**Enclosure 8 to E-50037**

**CoC 1004 Amendment 15 Application, Revision 2  
UFSAR Changed Pages  
(Public Version)**

**Figure 6-6-1**  
**Response Function Zoning**

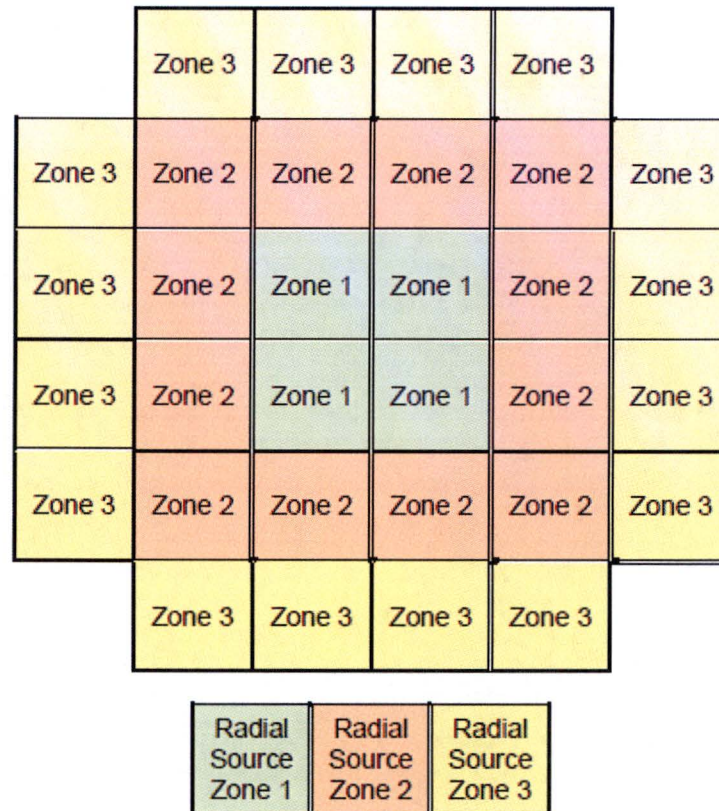
The three-zone response functions for the 32PTH1 Dry Shielded Canister (DSC) in FSAR Table U.5-15 and Table U.5-16 are developed for the three zones shown in FSAR Figure U.5-3 and reproduced below as Figure 6-6-1.

**Figure 6-6-2**  
**HLZC#6 for 24PTH-S and 24PTH-L DSCs with Type 1 Basket**

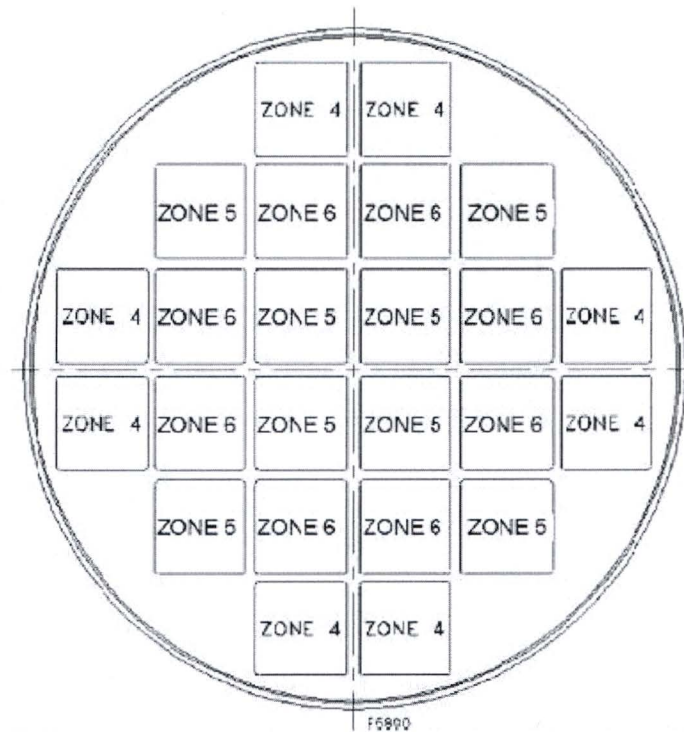
Heat load zone configuration (HLZC) #6 for the 24PTH DSC provided in Technical Specifications (TS) Figure 1-15a and reproduced below as Figure 6-6-2, includes three zones: Zone 4 (peripheral zone), Zone 5 (corner and central zones) and Zone 6 (inner zone).
